AR7030 technical bulletin 003

J309 FET Change and SD5400 Clamping Diodes

The FET modification

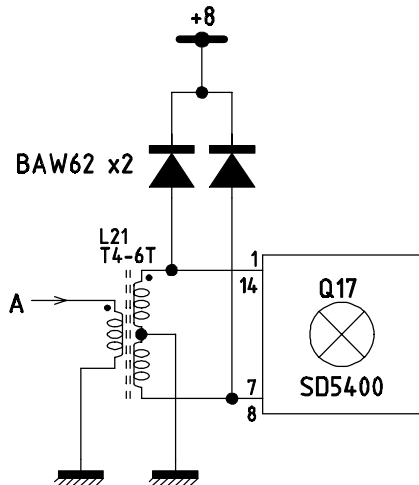
A 10k resistor is wired in parallel with a 10nF capacitor. This is then wired in series with the gate leg of the new FET as shown. This is carried out to both FET's.

Remove the old FET's and check L25 for damage - replace if necessary with a new 470uH choke. The new FET's are now fitted to the board - **the gate leg is the leg nearest the front panel of the set.**

The SD5400 diode clamping mod

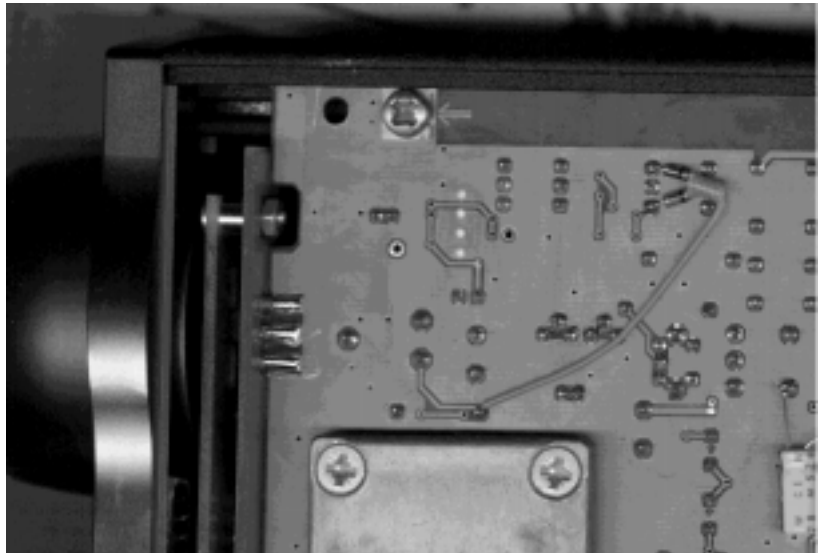
Replace the SD5400 if it's failure is suspected and in all sets add two diodes between the input transformer L21 and an 8V supply as shown below

We suggest that two silicon low capacitance diodes such as BAW62 are used. Twist the diodes together at the cathode end, solder and cut short. Cut both anodes short and solder each to one leg of the secondary winding of L21 on the underside of the board. Close proximity of the diodes to the SD5400 should be avoided, the diodes should therefore point towards the rear of the set being careful to insulate the cathode connection to avoid contact with the middle primary leg of L21 which is at +B potential. An insulated length of wire should be connected from the cathode connection pair to an 8V supply. A convenient point to pick up the 8V supply is at the top end of VR1 mixer bias preset.

Ideally the mixer bias should be reset after replacing the SD5400, however this will not be possible without specialist test equipment. We therefore recommend that the preset VR1 remains at the factory aligned setting for optimum performance.
